STAFF RECOMMENDATION
4028 Aberdeen Road
July 20, 2016

Application: New construction—addition; partial demolition
District: Cherokee Park Neighborhood Conservation Zoning Overlay
Council District: 24
Map and Parcel Number: 10308022800
Applicant: Cheyenne Smith
Project Lead: Melissa Baldock, melissa.baldock@nashville.gov

<p>Description of Project: Application is to demolish a rear screen porch and to construct a new rear addition.</p> <p>Recommendation Summary: Staff recommends approval of the project with the following conditions:</p> <ol style="list-style-type: none">1. Staff approve a stone sample;2. Staff approve the color and texture of the roof shingle if it does not match the existing house;3. Staff approve the final details, dimensions and materials of windows and doors prior to purchase and installation; and,4. The HVAC shall be located behind the house or on either side, beyond the mid-point of the house. <p>With these conditions, staff finds that the proposed demolition and addition meets Sections II.B. and III.B. of the Cherokee Park Neighborhood Conservation Zoning Overlay.</p>	<p>Attachments A: Site Plan B: Elevations</p>
---	--

Figure 3. the 1957 Sanborn Map

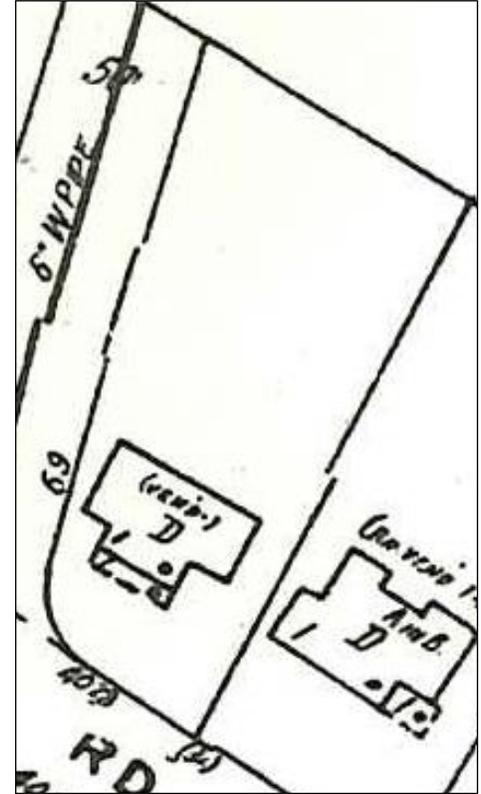
Demolition: The applicant proposes to demolish an existing, detached screened porch (Figures 3 & 4). The date of construction of the screened porch is not known, but it does not appear on the 1957 Sanborn maps. Staff finds that the porch's location, materials, design, and date of construction do not contribute to the historic character of the historic house and the Cherokee Park neighborhood. Staff therefore finds that its demolition

meets Section III.B.2 for appropriate demolition and does not meet section III.B.1 for inappropriate demolition.

EXTERIOR ELEVATIONS

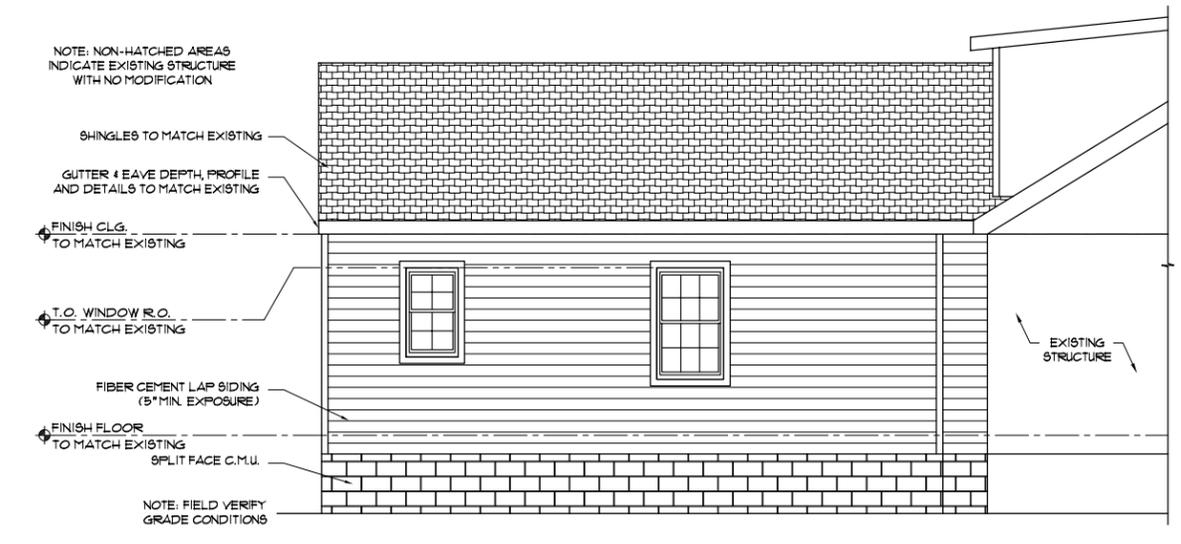
Staff finds that the height, depth, width, total square footage, and overall scale of the proposed addition are sufficiently subordinate to the historic house. Staff finds that the proposed addition meets Sections II.B.1.a., II.B.1.b., and II.B.2. of the design guidelines.

Design: The addition's change in materials, inset, separate roof form, and lower height help to distinguish it from the historic house and read as an addition to the house. At the same time, its scale, materials, roof form, and fenestration pattern are all compatible with the historic character of the existing house. Staff finds that the proposed addition meets Sections II.B.2.a and f. of the design guidelines.

Existing House	Proposed Addition
Primary Roof Form	Side gable, 7/12	Gable, 7/12
Secondary Roof Form	Gable, 7/12	Shed, 2/12

Staff finds that the addition’s proposed roof forms are compatible with the roof forms of the historic house and meets Sections II.B.1.e. and II.B.2. of the design guidelines.

Proposed Project	Appropriate?
Alterations to windows on existing house	Yes – altering windows on rear dormer constructed	Yes
Windows twice as tall as they are wide?	Yes	Yes
Largest Section of Wall Without a Window/Door Opening	9’	Yes

Staff finds the addition’s proportion and rhythm of openings to meet Sections II.B.1.g. and II.B.2. of the design guidelines.

Appurtenances & Utilities: No changes to the site’s appurtenances were indicated on the drawings. The location of the HVAC and other utilities was also not noted. Staff asks that the HVAC be located on the rear façade, or on a side façade beyond the midpoint of the house.

1. Staff approve a stone sample;
2. Staff approve the color and texture of the roof shingle if it does not match the existing house;
3. Staff approve the final details, dimensions and materials of windows and doors prior to purchase and installation; and,
4. The HVAC shall be located behind the house or on either side, beyond the mid-point of the house.
